Comment Letter O7: Perris Neighbors in Action, 5 pages

RE: Follow-up Comment on the Draft EIR for the Harvest Landing Retail Center and Business Park Project

Figure 2. CalEnviroScreen results for Census Tract 6065042620 where the proposed Project would be located.

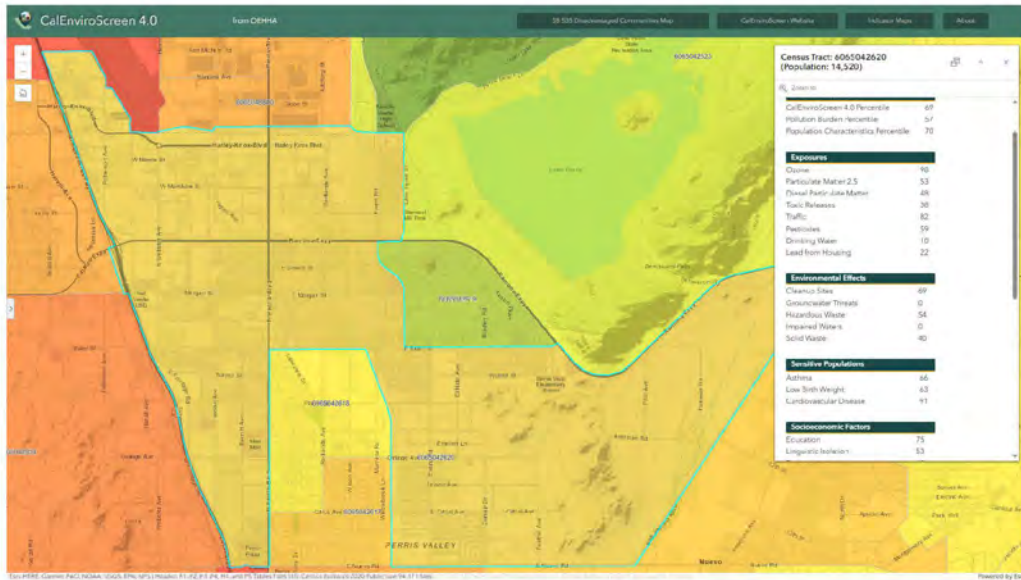
Comment O8.3: This comment expresses the commenters concern over the Projects' significant and unavoidable air quality and greenhouse gas (GHG) impacts in an area located in the 69th percentile on CalEnviroScreen as well as adjacent tracts which are in the top 25 most-impacts.

Response O8.3: CalEnviroScreen is a general policy tool. It is generally inappropriate for CEQA review as it relies on socioeconomic factors such as education and poverty rates which are not relevant under CEQA. CEQA is an environmental protection statute that is concerned with physical changes to the environment (CEQA Guidelines Section 15358(b)). The environment includes land, air, water, minerals, flora, fauna, ambient noise, and objects of historic or aesthetic significance (CEQA Guidelines Section 15360). The Project's potential environmental justice effects are social issues that are not considered effects on the environment (CEQA Guidelines Sections 15064(e) and 15131(a)). Thus, consistent with CEQA, the Draft EIR includes an analysis of the Project's potentially significant physical impacts on the environment and does not include substantial discussion of environmental justice. However, the Draft EIR provides a detailed evaluation of the potential cumulative air quality related impacts of the proposed Project upon the surrounding community (localized impacts) pursuant to South Coast AQMD methodology and thresholds, which is appropriate due to the Project's location within the South Coast Air Basin. The comment asserts lack of adequate mitigation but does not recommend any specific additional mitigation.

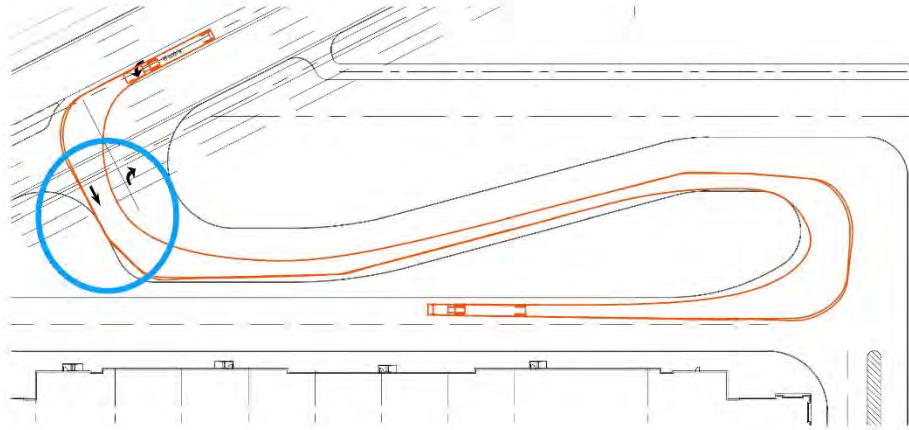
The same is true for the truck entering the site via Frontage Road at Building 6, which will overlap on the internal curb, indicating there is not suitable available space to accommodate truck maneuvering. This exhibit also does not depict two trucks simultaneously entering and exiting site and there does not appear to be enough maneuvering space for two trucks given that there is not enough area for a single truck without overlapping on the internal curb. The geometric design of the circulation system and project site will substantially increase hazards and a significant and unavoidable impact exists, which must be disclosed in a revised EIR.

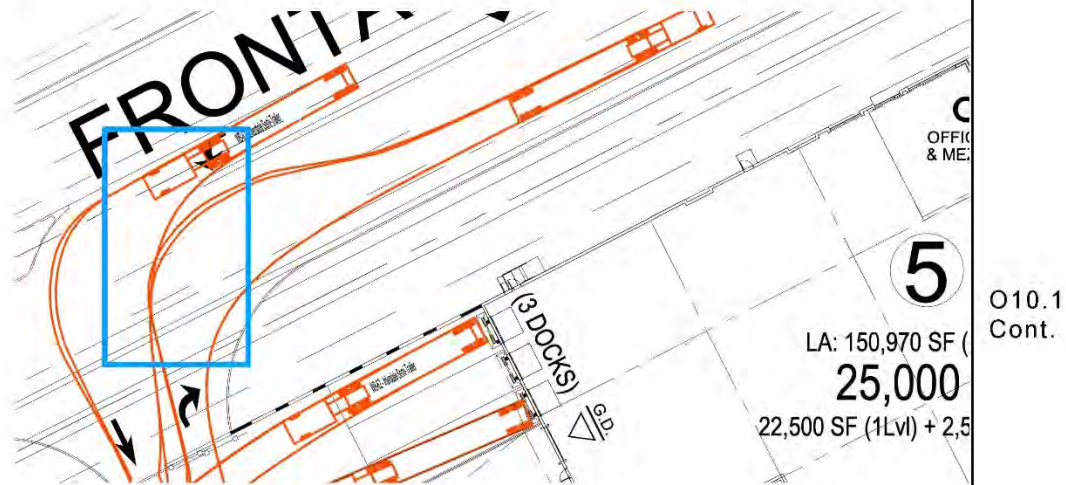
It is particularly notable that the trucks accessing the site via Frontage Road at Building 5 will collide on Frontage Road. The geometric design of the circulation system and project site will substantially increase hazards and a significant and unavoidable impact exists, which must be disclosed in a revised EIR.

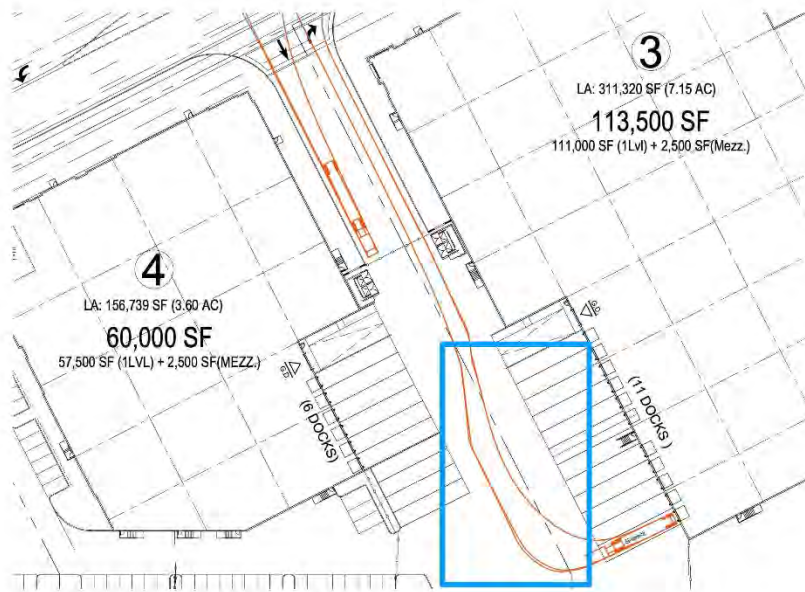
Additionally, trucks accessing the internal truck/trailer loading dock court between Buildings 3 and 4 do not have adequate internal maneuvering space. As shown below, a single truck backing into a loading dock space requires the entire loading dock area to maneuver into the space. There is no other maneuvering area available, meaning that other trucks must queue and wait for the area to clear in order to proceed. Increased queuing results in increased idling (and associated emissions) will require increased internal queuing area in order to avoid queuing on Frontage Road. The geometric design of the circulation system and project site will substantially increase hazards and a significant and unavoidable impact exists, which must be disclosed in a revised EIR.

Figure 1. Actual and predicted relationships between the numbers of vertebrate wildlife species detected and the elapsed survey time based on Noriko's visual-scan surveys on 18 and 21 July 2025.

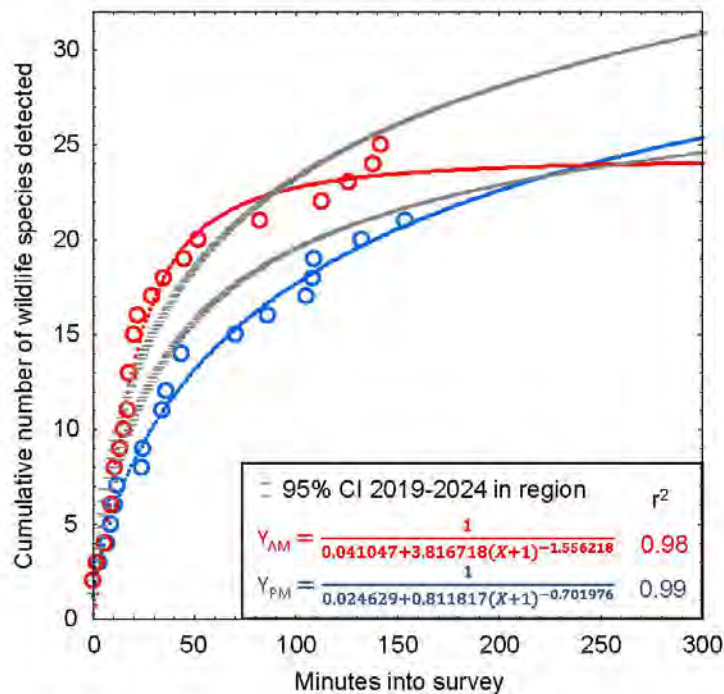
Noriko detected 33 species of vertebrate wildlife, which was a relatively large number for the brevity of her survey effort. However, the species of wildlife Noriko detected at the project site were not the only species that were present during her surveys, as some species typically go undetected. To demonstrate this, I fit nonlinear regression models to Noriko's cumulative numbers of vertebrate species detected with time into her surveys to predict the numbers of species that she would have detected with longer surveys or perhaps with additional biologists available to assist her. The model is a logistic growth model which reaches an asymptote that corresponds with the theoretical maximum number of vertebrate wildlife species that could have been detected during the survey. The model fit to Noriko's evening survey data, for example, predicts 41 species of vertebrate wildlife were available to be detected that evening, or twice the number of species she detected that evening (Figure 1). Her rate of species detections during the morning survey followed and even exceeded the upper bound of the 95% confidence interval I estimated from other morning surveys in the region (Figure 1).

Response O10.6: The Project site's environmental conditions are not comparable to the conditions that the commenter describes for the Altamont Pass Wind Resource Area. The Project site is surrounded by urban development on all sides including I-215 to the west, retail and residential uses to the south, commercial and residential uses to the east, and public and industrial uses to the north. The Altamont Pass Wind Resource Area is located in a rural area of Northern California. Therefore, the two locations are not comparable for purposes of onsite biological habitat. Furthermore, biological analysis under CEQA does not rely on modeling for an estimate of how many species could occur onsite, but on the review of existing databases and field surveys.

Figure 2. Actual and predicted relationships between the numbers of bat species detected and the elapsed survey time based on Noriko’s nocturnal survey on 18 July 2025.

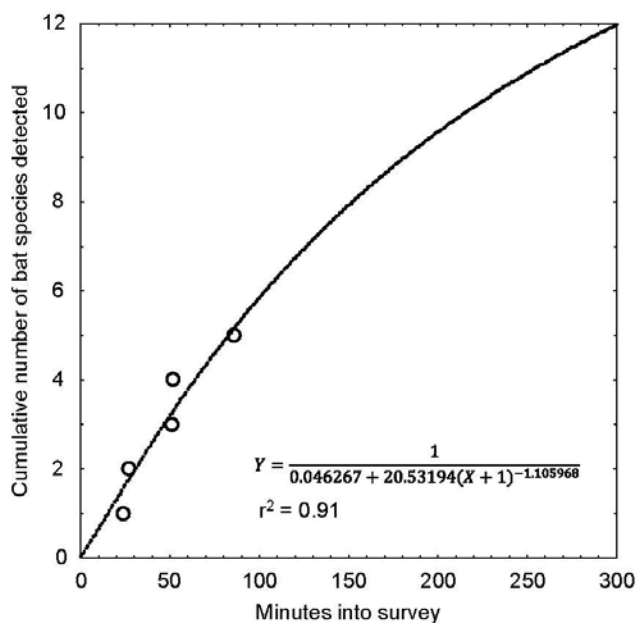
The same type of model fit very well to Noriko’s cumulative number bat species detections with increasing time into her nocturnal survey (Figure 2). The model predicts that had she continued her survey for five hours, she would have detected 12 species of bats.

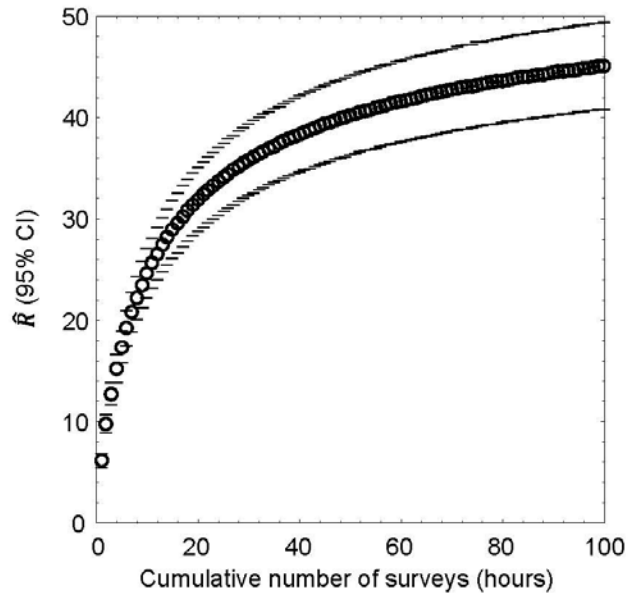
Because my prediction of 86 species of vertebrate wildlife, including 21 special-status species, is derived from daytime visual-scan surveys, and would detect few nocturnal mammals such as bats, the true number of species composing the wildlife community of the site must be larger. Noriko's reconnaissance surveys should serve only as a starting point toward characterization of the site's wildlife community, but it certainly cannot alone inform of the inventory of species that use the site. More surveys are needed than her two surveys to inventory the project site's wildlife community. Nevertheless, the large number of species I predict at the project site is indicative of a relatively species-rich wildlife community that warrants a serious survey effort. The patterns in the data and what I know of nocturnal species, I predict at least 120 species of vertebrate wildlife rely on the project site as habitat.
